AGENDA

STATE BUILDING CODE TECHNICAL REVIEW BOARD

Friday, July 21, 2023 - 10:00am

REQUEST FOR INTERPRETATION

Figure 3—Crawlspace Stemwall with Masonry Above Grade

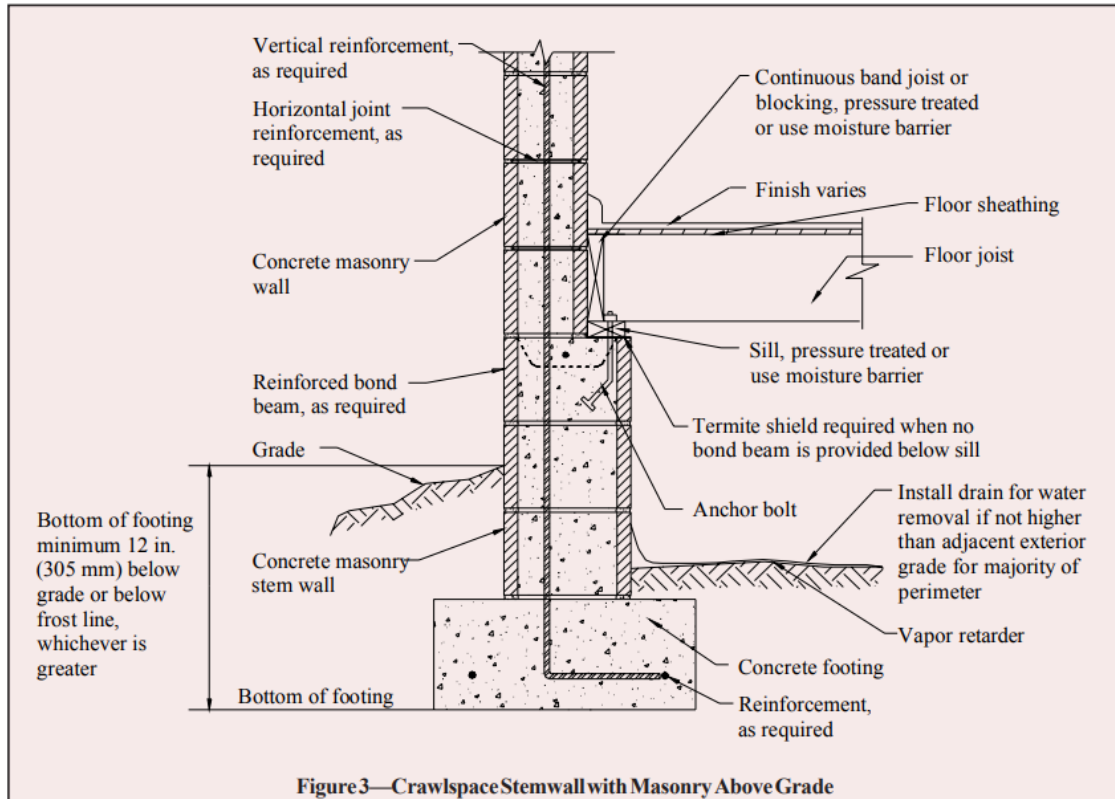
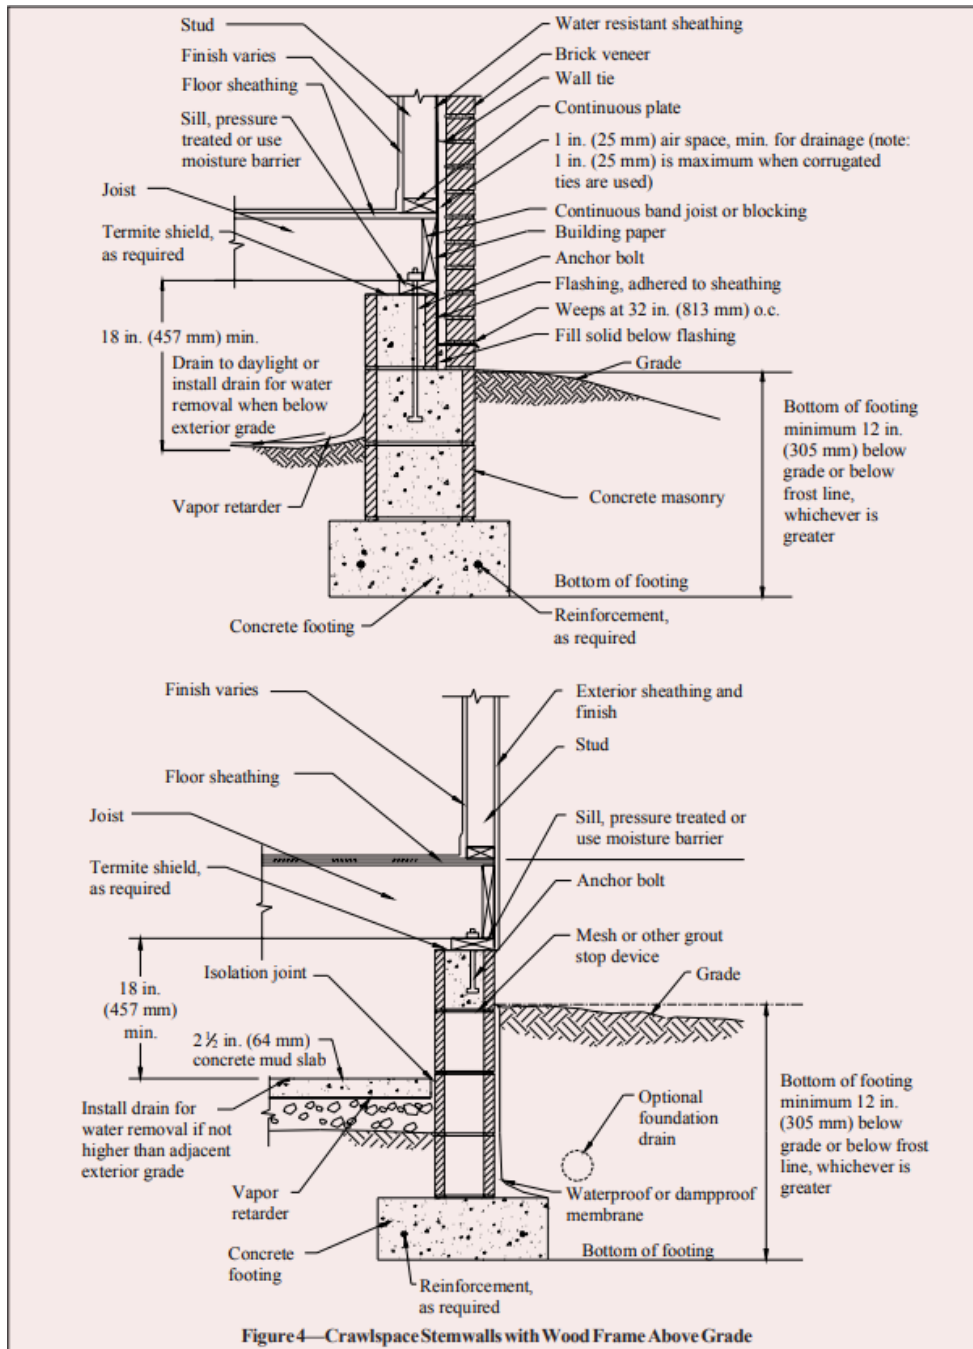
2) If only the top one or two masonry unit cells are required to be grouted how is the grout pour stopped at that level? NCMA TEK 05/03A does show adding a mesh or other material to stop grout flow in Figures 3 and 4.
